WILLIAMSON COUNTY, TEXAS  
CHANGE ORDER NUMBER: 3

Project: 1608-108  
Roadway: RM 620 Ph2  
CSJ Number: \_\_\_\_\_

**3F: County Convenience. Additional work desired by the County.** This Change Order adds modifications to the left turn lane median turn bay on O'Connor Drive, north of RM 620. This is considered a major change order because it changes the project limits. This work was requested by the County.

O'CONNOR DR NEAR  
 RM 620 HEB TURN LANE  
 MEDIAN TURN BAY  
 ROADWAY PLAN

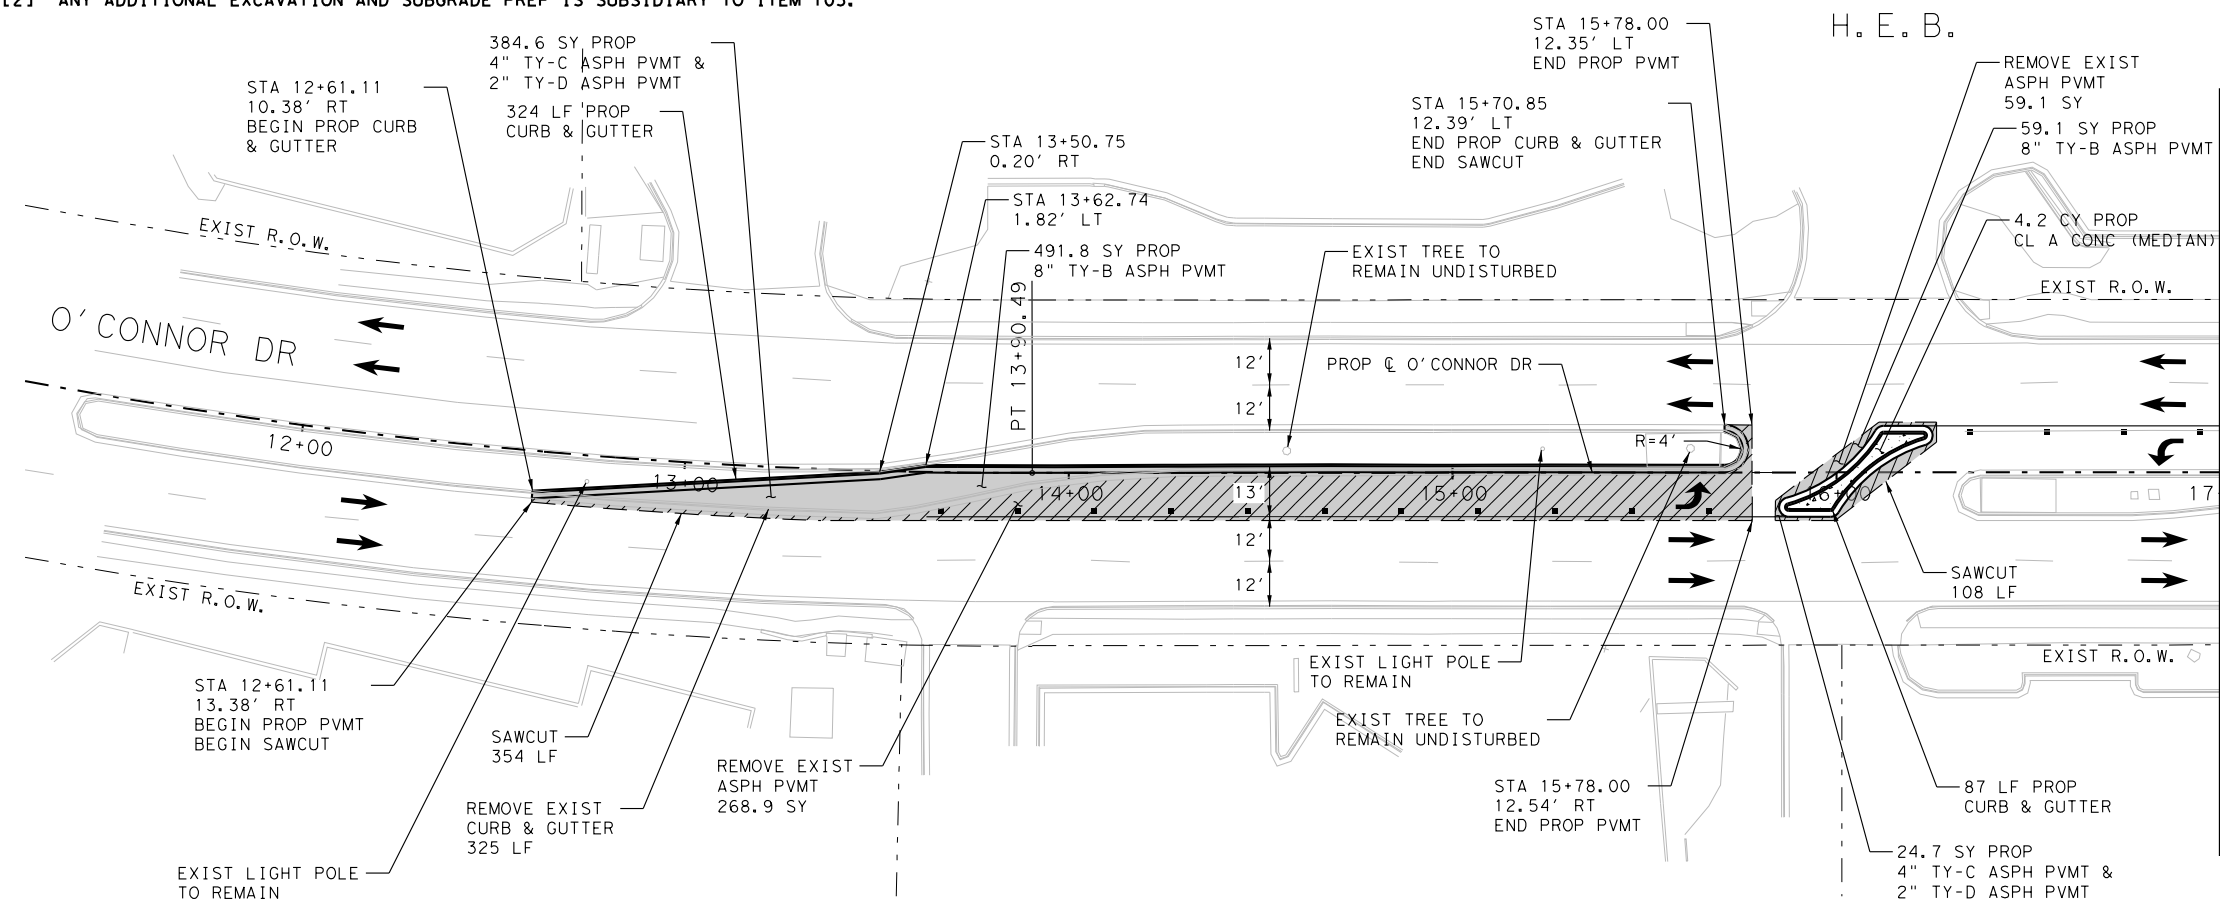
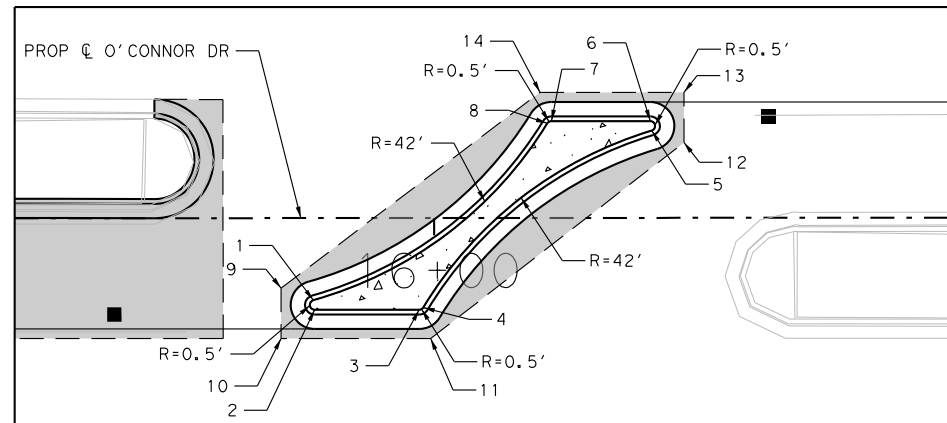
- Work to be performed in accordance with Items: See attached
- New or revised plan sheet(s) are attached and numbered: New plan sheets entitled, "O'Connor Drive near RM 620 HEB turn lane."
- New Special Provisions/Specifications to the contract are attached: No
- New Special Provisions to Item N/A No. N/A, Special Specification Item N/A are attached.
